## MEMORANDUM

**To:** Craig M. Failor – Oak Park Village Planner  
**From:** Floyd D. Anderson, AIA & Rich Van Zeyl, AIA  
**Date:** 9/15/2021  
**Subject:** 7 Van Buren  
**PD #:** PL202100020  
**Developer:** Oak Park Residence Corporation  
**Architect:** Kahler Slater

The purpose of this memo is to review the proposed Planned Development at 7 Van Buren, which is a six-story building with 45 dwelling units and 17 parking spaces. The applicant met once with Wight and Company in March of 2020 to present the initial concepts for the design. The project is seeking relief for several zoning issues including an increase in height from 45' to 70'-3", increase in lot coverage and minimum lot area, reduction in setbacks, reduction in parking, and reduction in loading. The project is planned as a net zero energy building.

**7 Van Buren Development - View from Northeast**

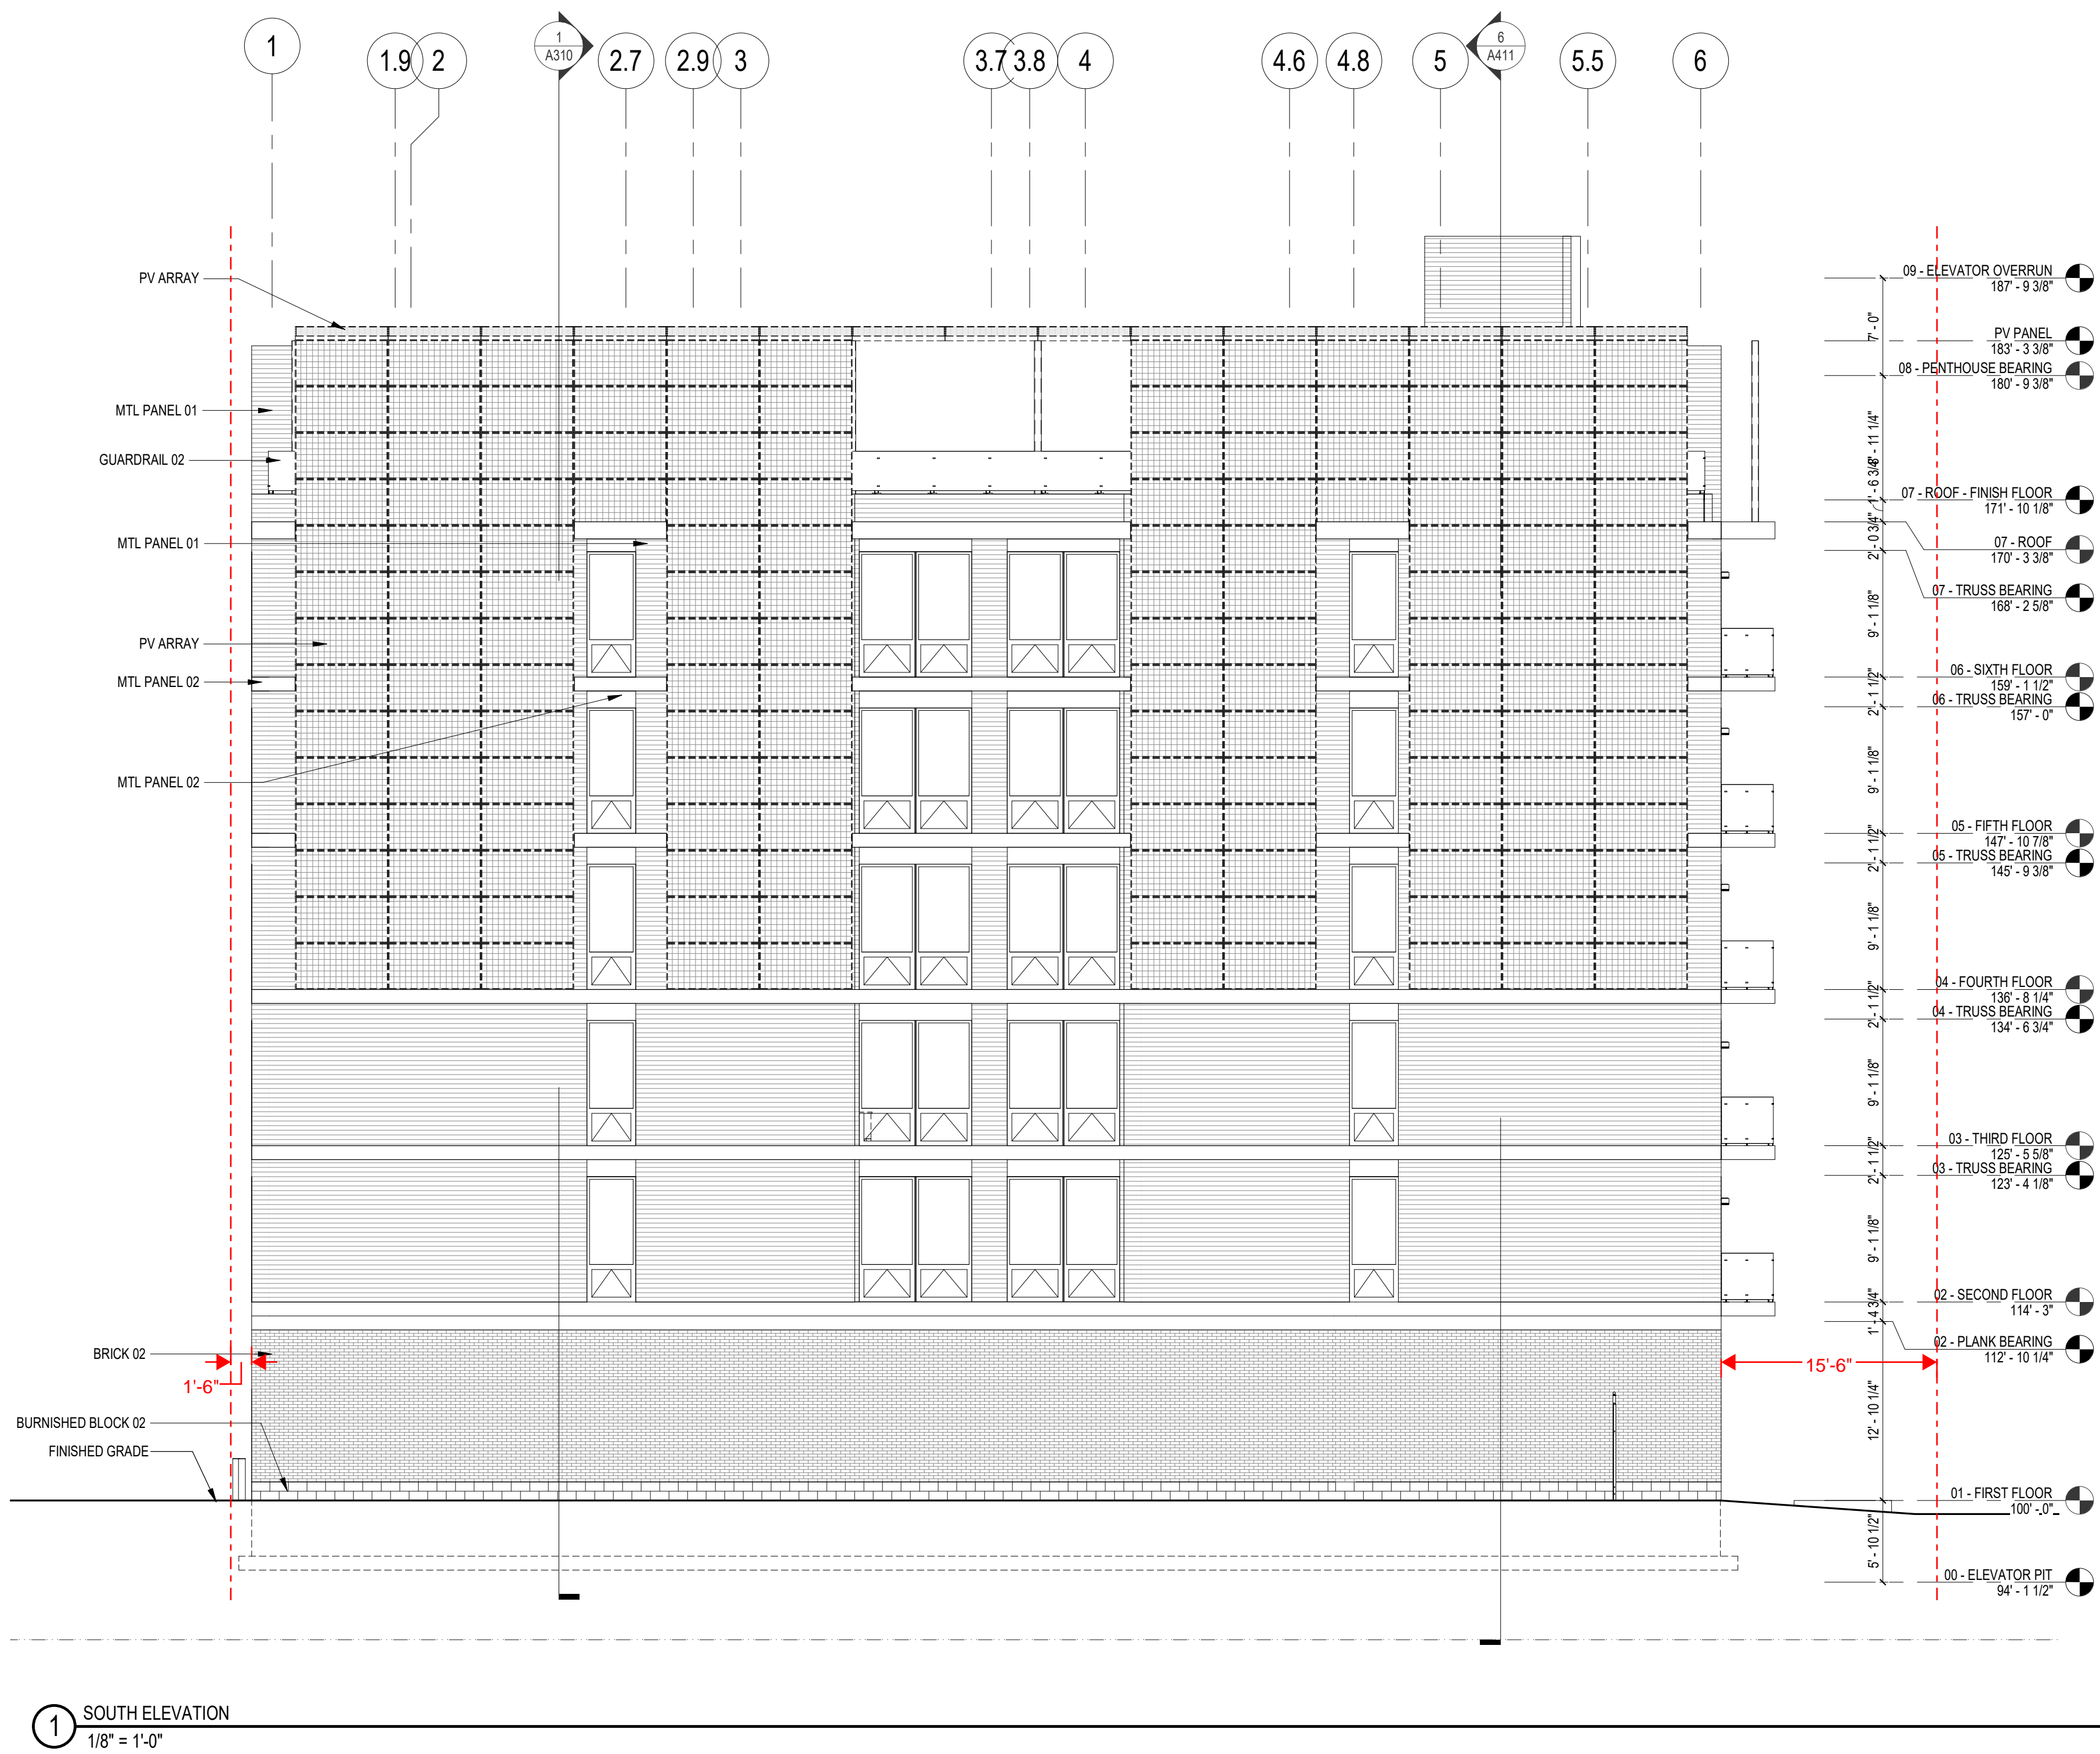
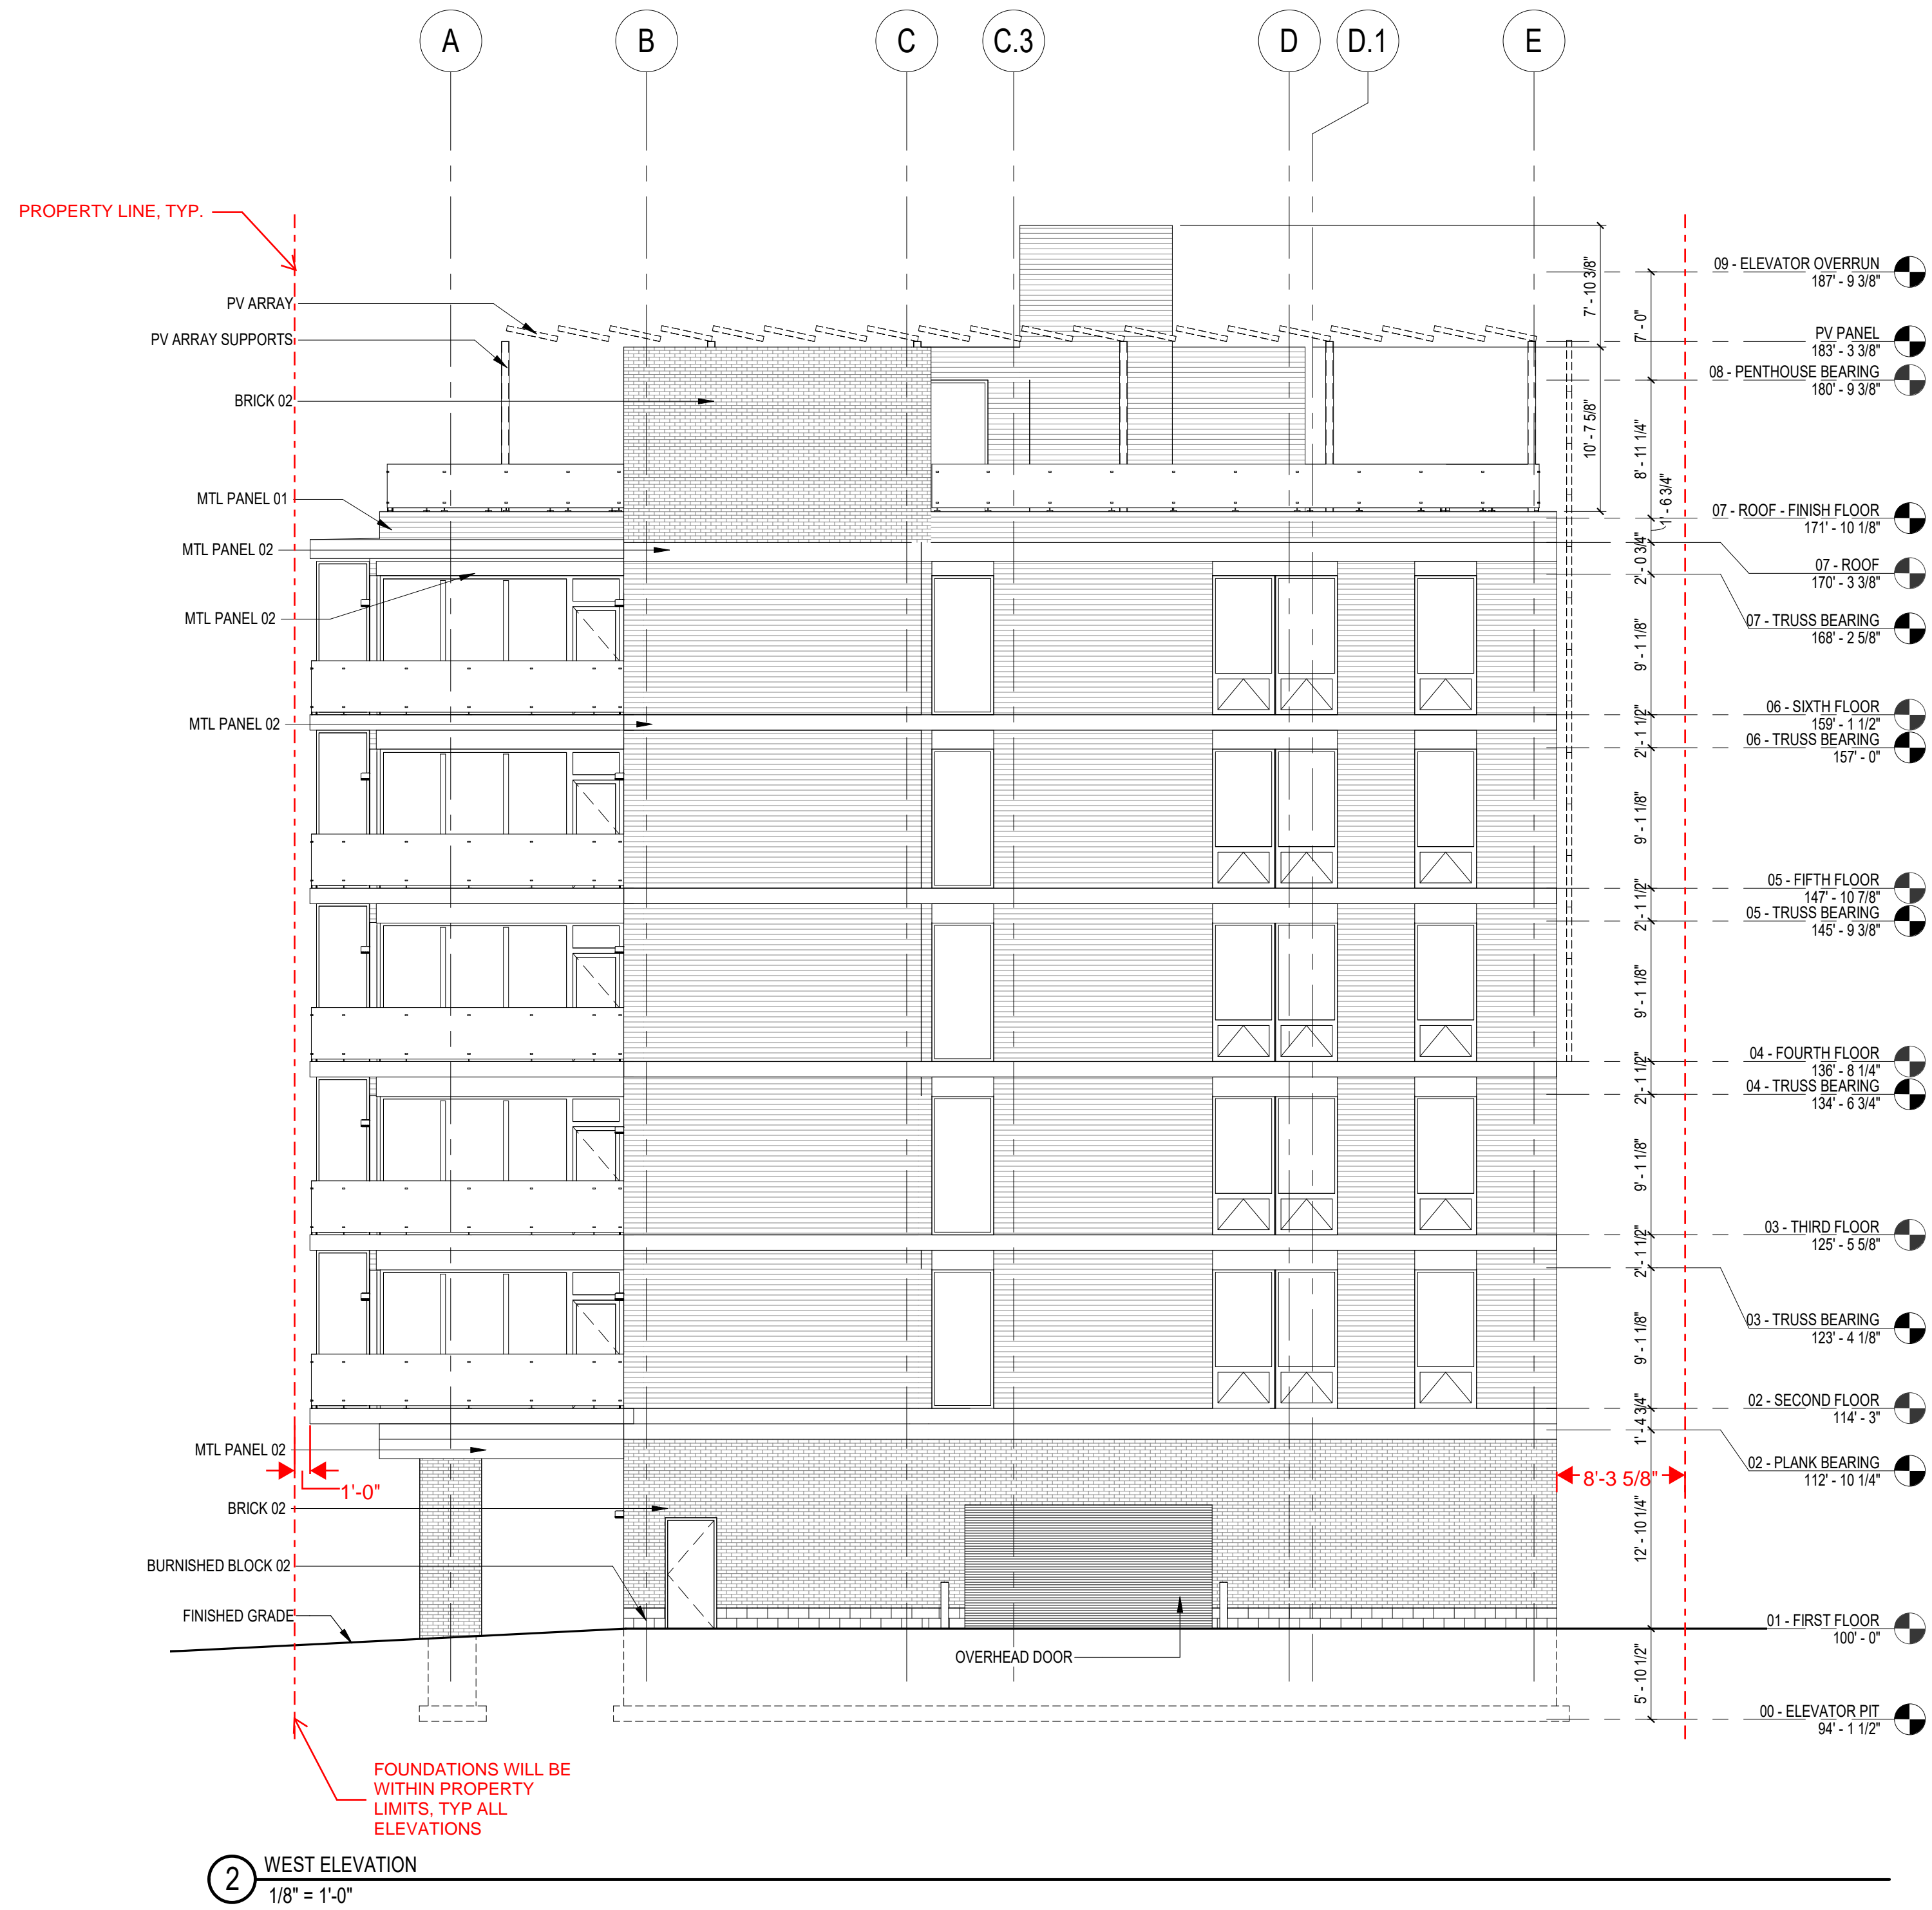
2. It would be helpful to see a few more perspective views of the building, particularly looking east down Van Buren, and looking north or south along Austin to see it in context with the adjacent buildings.

ROOF PLAN - PV  
PANELS

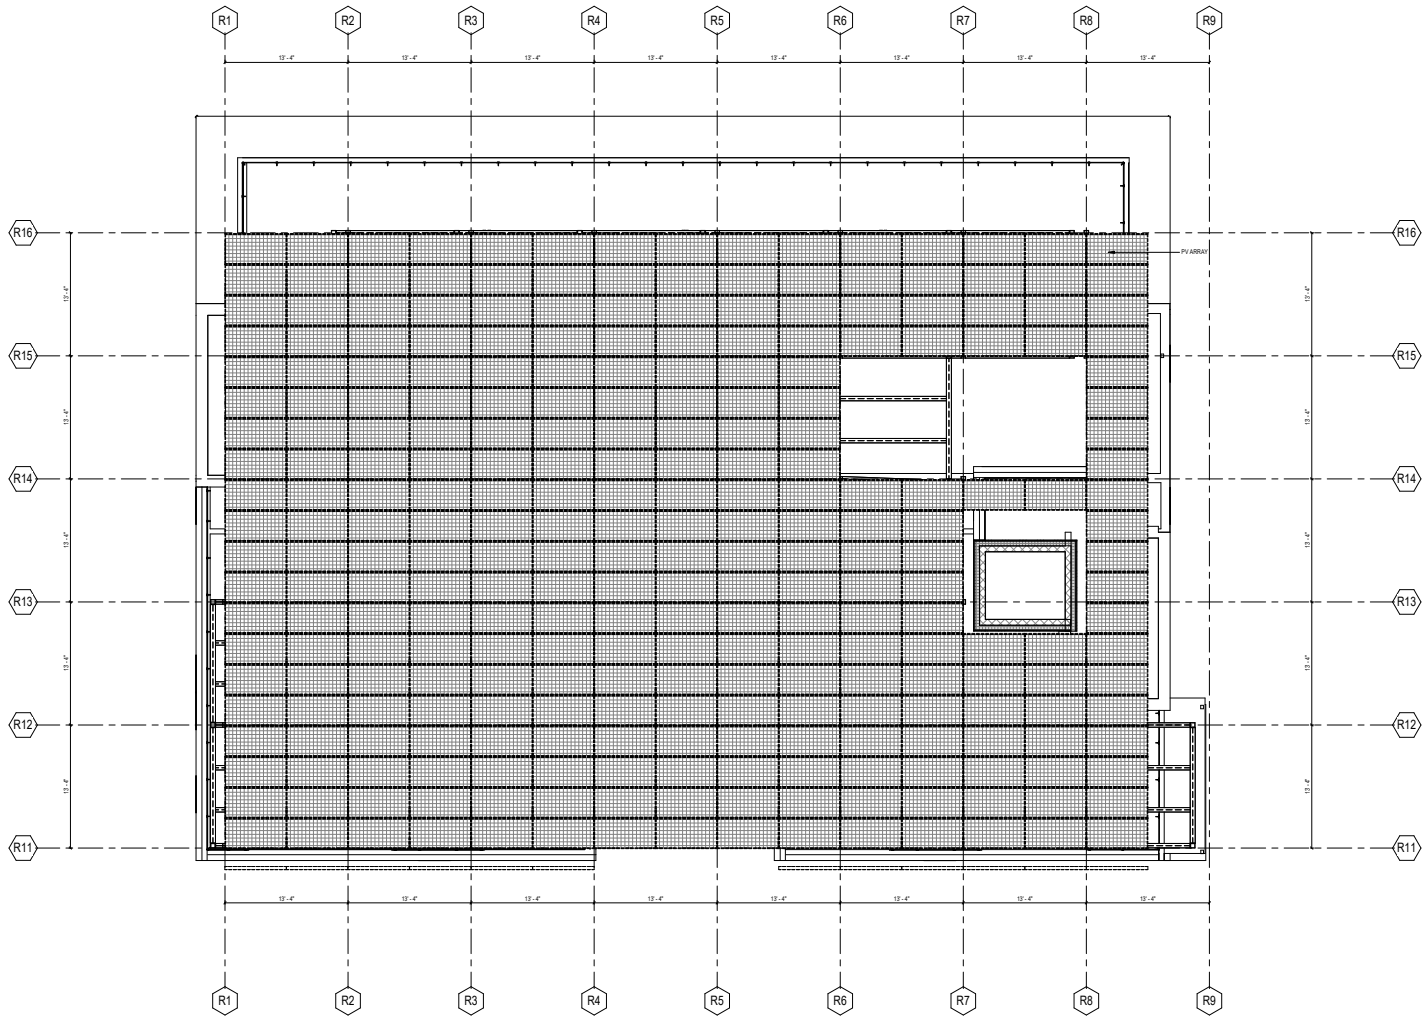
1. It is unclear from the drawings what the photovoltaic panels will look like since they do not show up in the renderings or on the plans. What are the details? How are they attached? We need to see more information about this system to fully understand it and comment on the design.
